<b>TO:</b>	<b>CHAIR AND MEMBERS PLANNING AND ENVIRONMENT COMMITTEE</b>
<b>FROM:</b>	<b>GEORGE KOTSIFAS DIRECTOR OF BUILDING CONTROLS AND CHIEF BUILDING OFFICIAL</b>
<b>SUBJECT:</b>	<b>HIGHLAND RIDGE SANITARY TRUNK SEWER  PROPONENT: CITY OF LONDON LOCATION: 890 SOUTHDALE RD. WEST  PUBLIC PARTICIPATION MEETING ON MONDAY MAY 7, 2012 - NOT TO BE HEARD BEFORE 4:30 P.M.</b>

That, on the recommendation of the Senior Planner, Development Services, the following actions **BE TAKEN** with respect to the Environmental Impact Study (EIS) for the Highland Ridge Sanitary Trunk Sewer (Dillon Consulting, July 2011) for the City of London:

HIGHLAND RIDGE SANITARY TRUNK SEWER EIS

**PROJECT PLAN**

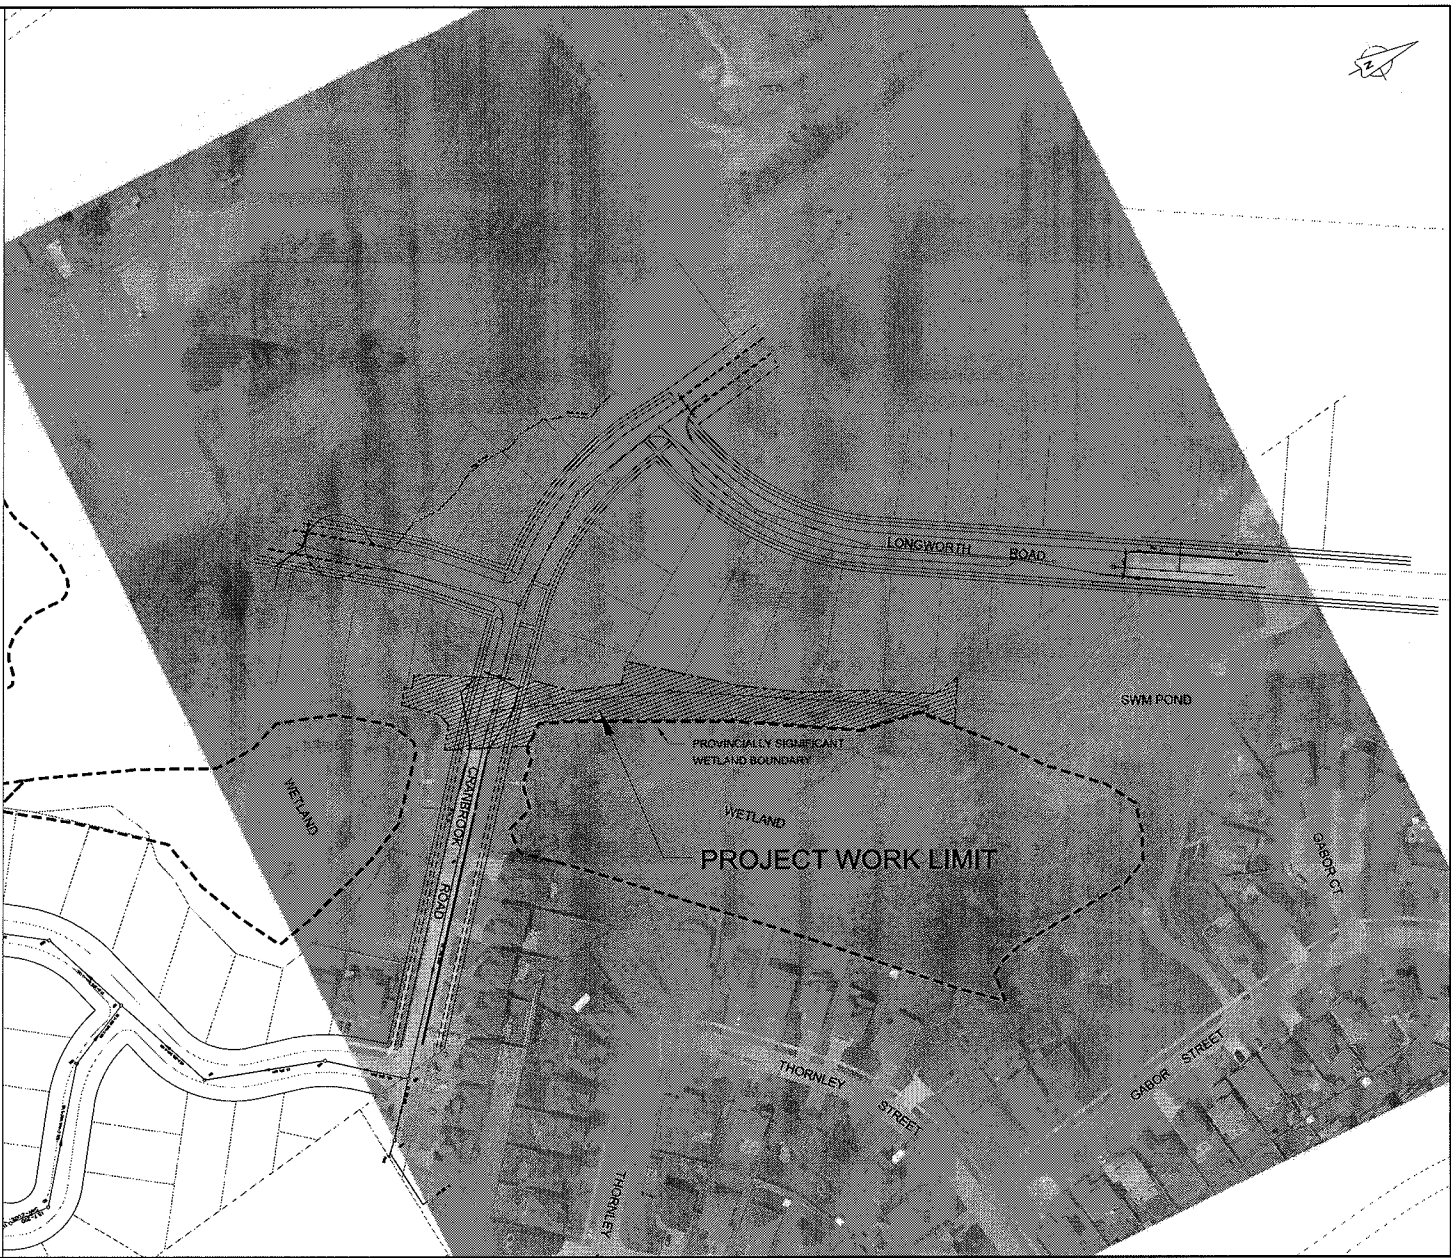
- In response to MNR questions concerning the wetland boundary and confirmation that the sanitary sewer alignment is outside of the wetland, the PSW boundary from Schedule "B1" of the Official Plan, and the PSW boundary from the most recent mapping layer that had been provided to the City by the MNR have been compared. It can be confirmed that the MNR boundary and the City boundary are virtually coincidental in the vicinity of the proposed trunk alignment. We can therefore confirm that the City of London has used the correct wetland boundary. This boundary was used to establish the buffer for the Highland Ridge Subdivision EIS and is the same boundary used in the Highland Ridge Sanitary Sewer EIS.

- The restoration drawings in the EIS identify the limit of the wetland (labelled as regulatory limit – it is presumed that this limit is the same limit as the MNR wetland boundary) and these drawings demonstrate that despite the “pinch point” at the eastern edge, there is still sufficient room to install the sewer and protect the wetland from direct impact.

- In conclusion, the EIS is complete and has addressed MNR’s outstanding concerns. There is no reason to revisit the wetland boundary as previously surveyed. It is recommended that the consultant confirm the “regulatory limit” of the wetland, as shown on the restoration drawings, is the MNR/City limit.

Also, in response to the comments from MNR, the wetland mapping shown on the construction drawings in the EIS has been updated to accurately reflect the delineation of the latest wetland boundary, as identified by Land Information Ontario. Based on this updated mapping, it can be confirmed that the sanitary trunk sewer will be constructed outside the boundary of the PSW.
